# SAFETY RECALL NOTICE

## **Re: Front Fenders Electrical Harnesses May Be Loose - Potential Loss of Power**

# WARRANTY BULLETIN SAFETY CAMPAIGN

**October 31, 2022** Subject: **Front Fenders Electrical Harnesses May Be Loose – Potential Loss of Power**

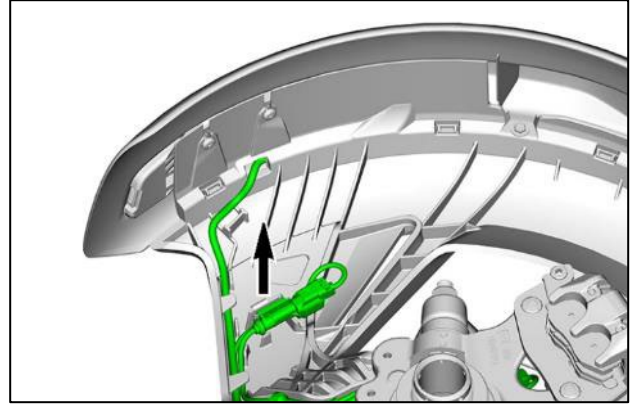
1. Safely lift front of vehicle.
2. Remove RED locking clip, nut and wheel.
3. Remove and discard locking tie clip from the inside of the fender.

4. Inspect the harness condition. If it was previously damaged, it will need to be repaired.

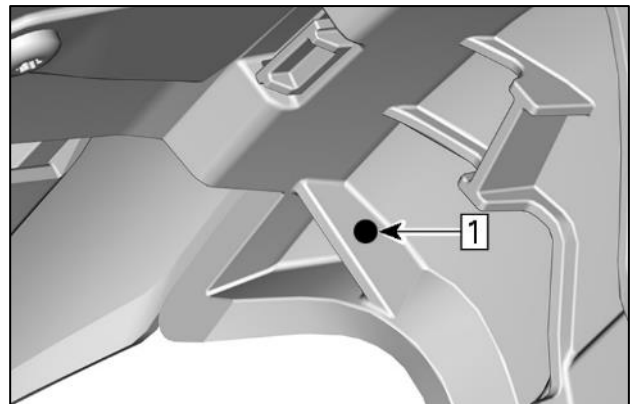
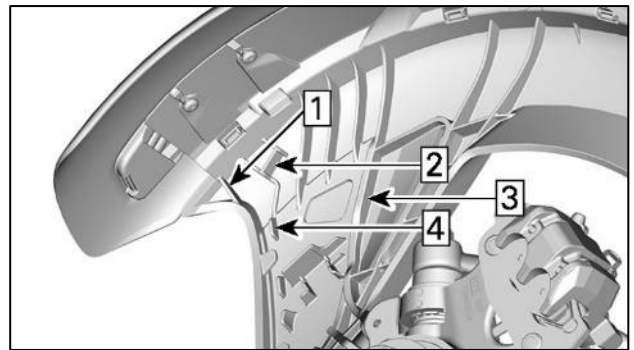
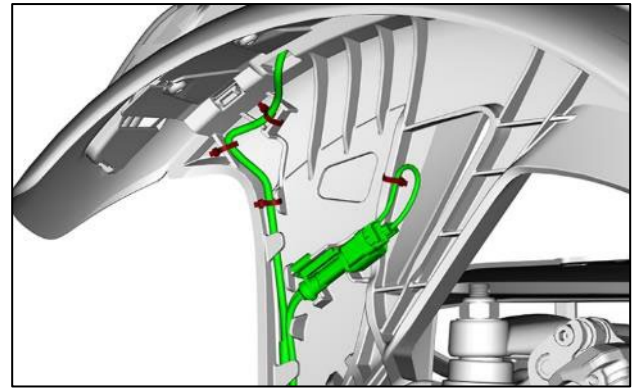
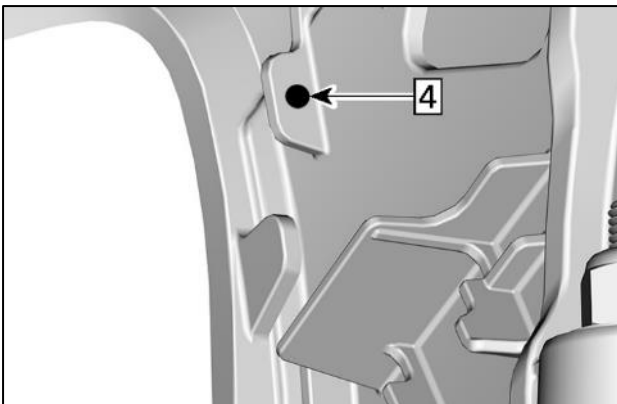
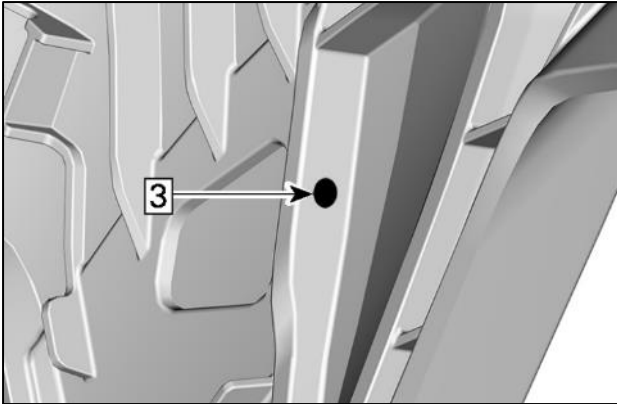
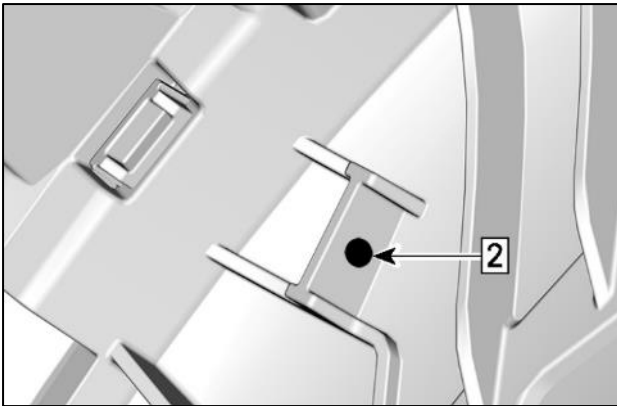
5. Unclip harness connector and pull harness out of location to provide access for drilling.

6. Drill 1/8 in (3 mm) holes in the four tabs at the following locations.

**NOTE:** Use a 90 degree drill as the access is limited.

7. Route harness in place and clip connector.
8. Install new locking ties (1 at each drilling location to support the wiring harness properly). Cut exceeding length.
9. Ensure routing is as follows.
